HISTORIC AND DESIGN REVIEW COMMISSION COMPLIANCE AND TECHNICAL ADVISORY BOARD

HDRC CASE NO: 2025-079
ADDRESS: 1232 VIRGINIA BLVD
LEGAL DESCRIPTION: NCB 3888 BLK 4 LOT 9
ZONING: RM-4, H
CITY COUNCIL DIST.: 2
DISTRICT: Knob Hill Historic District
APPLICANT: Richard Gonzalez
OWNER: Richard Gonzalez/CHAPAWU PROPERTIES LLC
TYPE OF WORK: Front and rear yard fence installation
APPLICATION RECEIVED: March 14, 2025
60-DAY REVIEW: May 13, 2025
CASE MANAGER: Edward Hall

REQUEST:

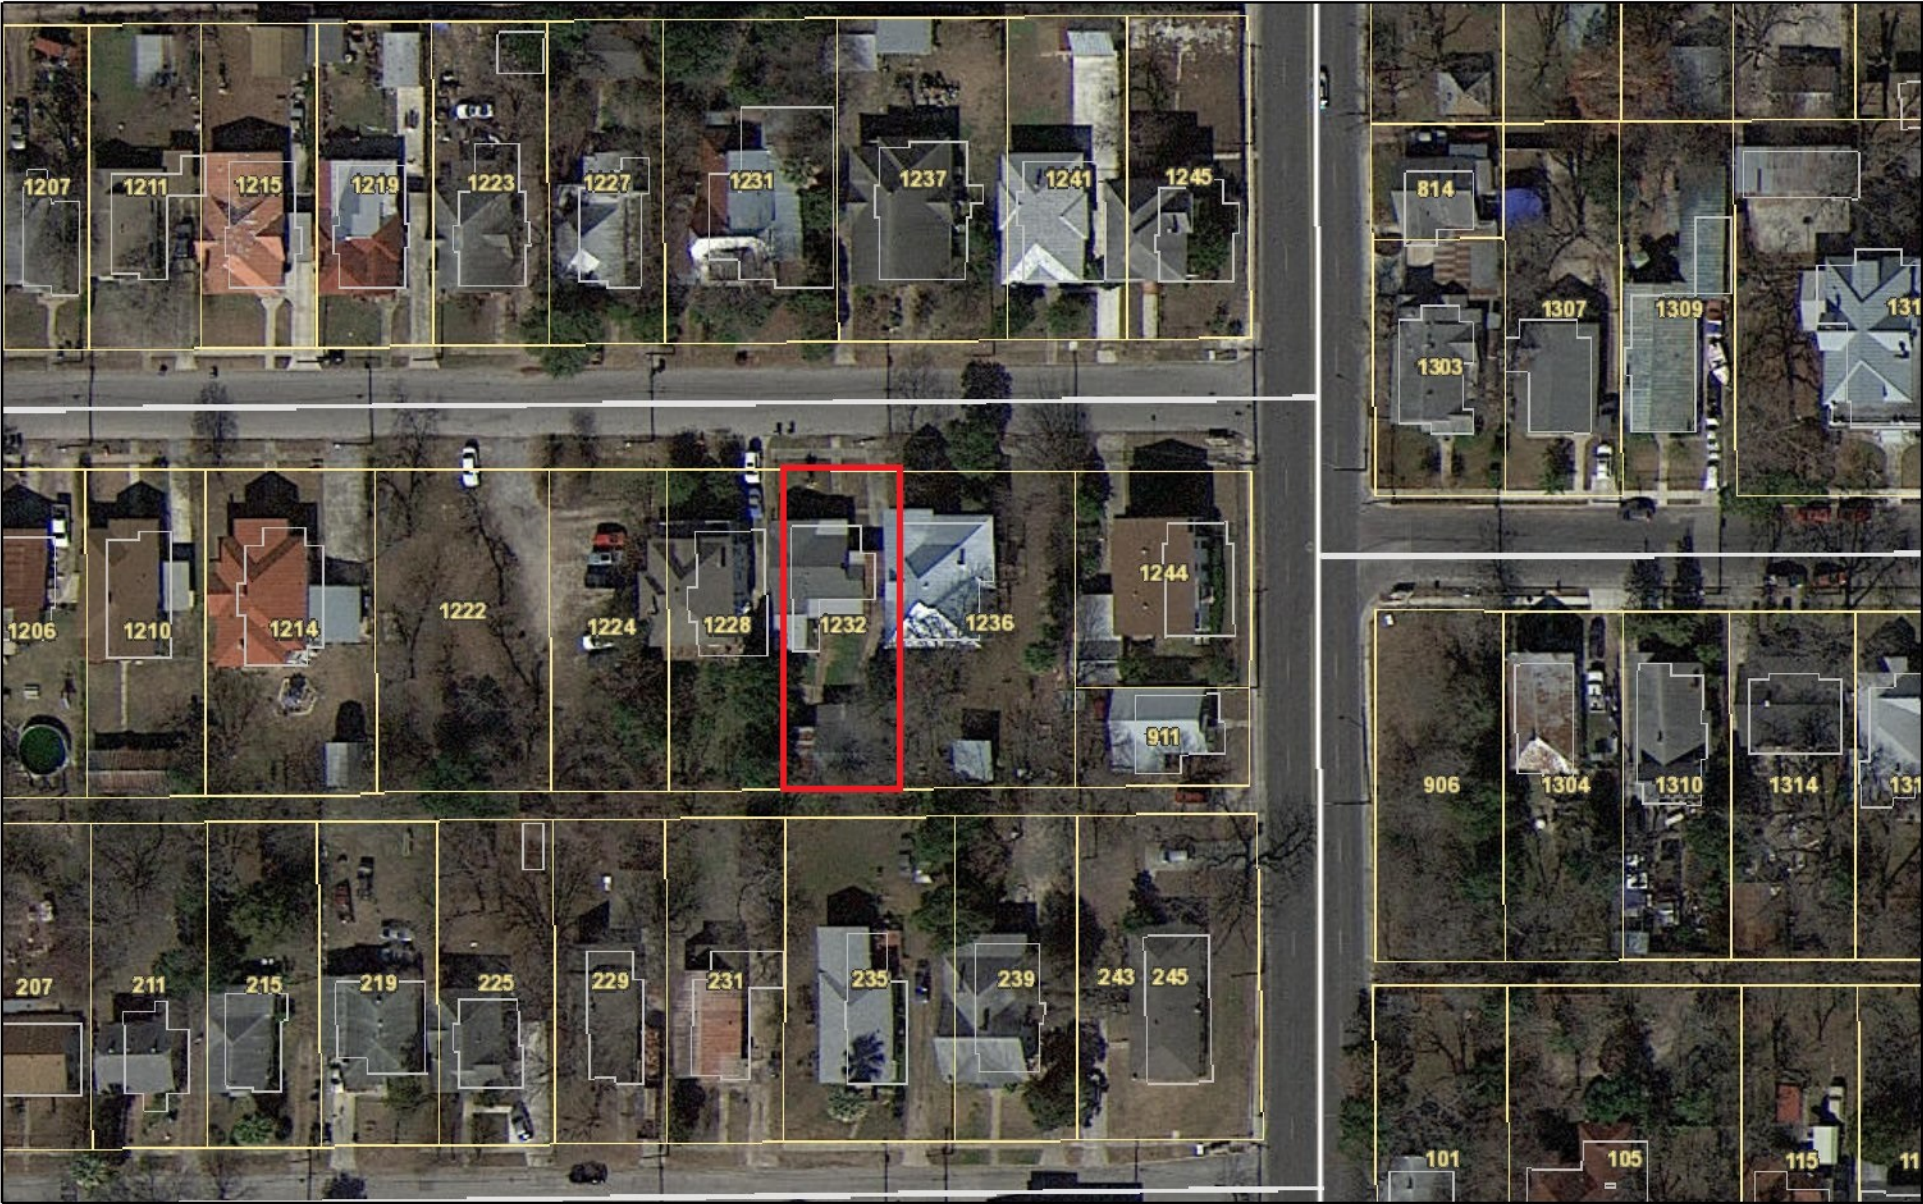
- b. FENCING – The applicant has proposed to install a new, front yard, cattle panel fence. The proposed fence will feature an overall height of four (4) feet. The Guidelines for Site Elements 2.B.v. notes that new fences should be constructed of materials used historically within the district. Additionally, the Guidelines note that fences should respond to the design and materials of the historic structure. Generally, staff finds the installation of a cattle panel fence to be appropriate; however, staff finds that the fence should feature posts that feature 4 inches square, a top and bottom rails featuring approximately 2x4 inches, and side rails featuring a width of at least 1.5 inch. Side rails are to be installed on the panel side of each post.

Staff recommends approval based on findings a and b with the following stipulations:

- i. That the fence feature posts that feature 4 inches square, a top and bottom rails featuring 2” x 4” dimensions, and side rails featuring a width of at least 1.5 inch. Side rails are to be installed on the panel side of each post.
- ii. That a driveway gate not be installed unless it is installed behind the front façade.
